County of Fairfax, Virginia

STAFF REPORT

APPLICATION RZ/FDP 2009-PR-002

APPLICANT: Square 1400, L.C.

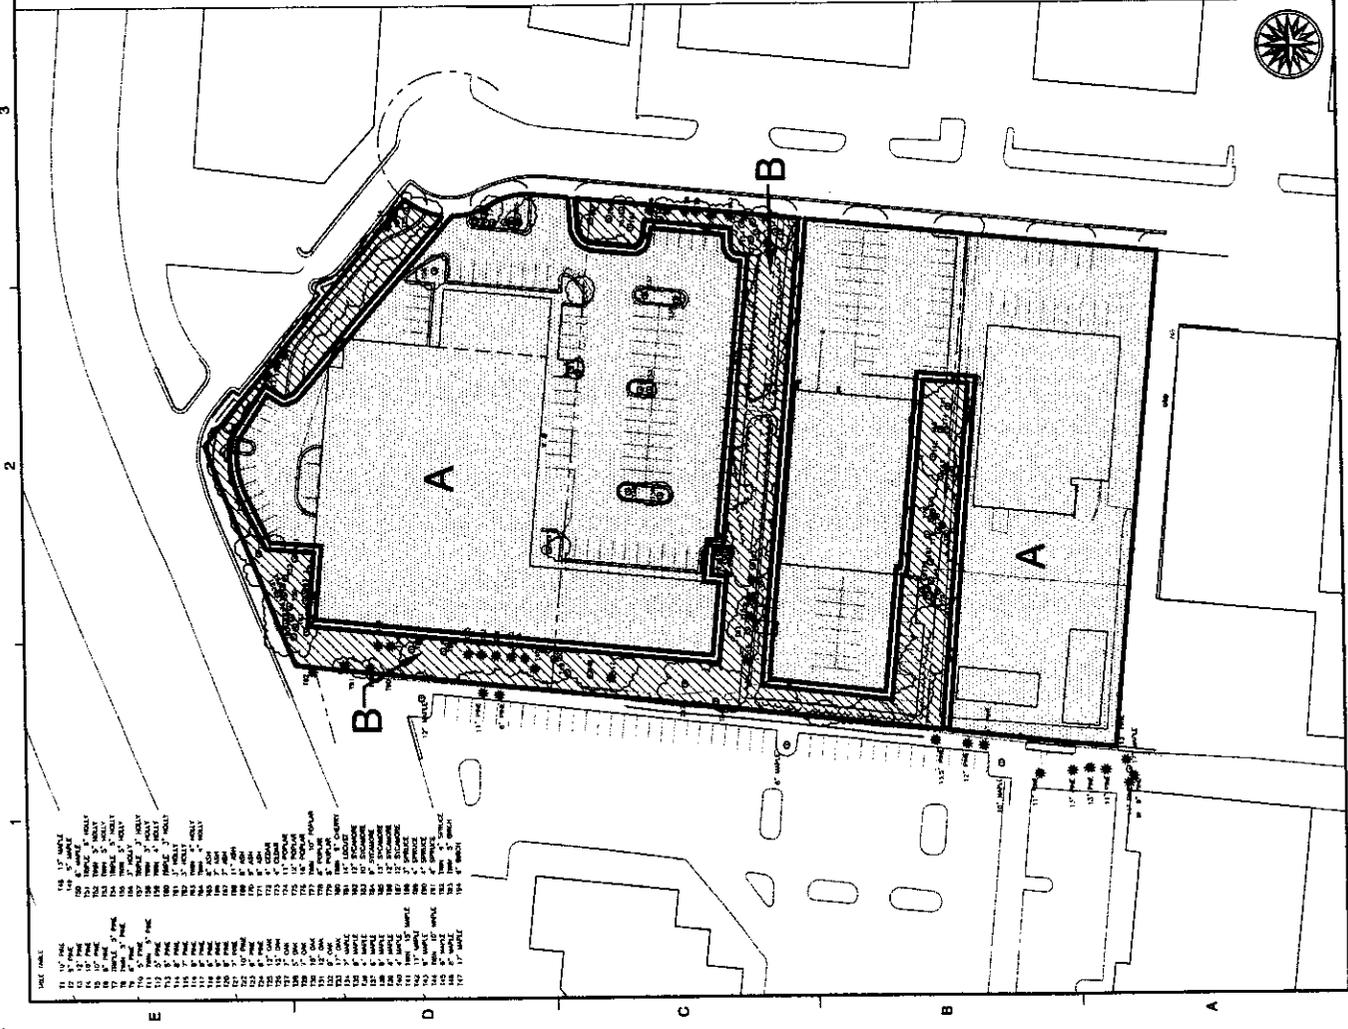
In addition, staff is concerned that the Tree Preservation Target Calculations indicate that the tree preservation target minimum (16.55% or 3,316 square feet of gross site area covered by existing tree canopy) shown on Sheet 14 of the CDP/FDP, would not be met for the site. Staff recommended that a deviation from the tree preservation target should be provided that states one or more of the justifications listed in PFM 12-0507.3 along with a narrative that provides a site-specific explanation of why the tree preservation target would not be met. The applicant has provided a request for a deviation on Sheet 14 of the CDP/FDP. Final determination would be made at site plan review.

- Comment:** The Tree Preservation Target Calculations shown on sheet 1 of the EVM indicate the tree preservation target minimum will not be met for this site. Instead, it appears the 10-year canopy requirement is being met entirely through landscaping, as shown on sheet 5 of the CDP/FDP.
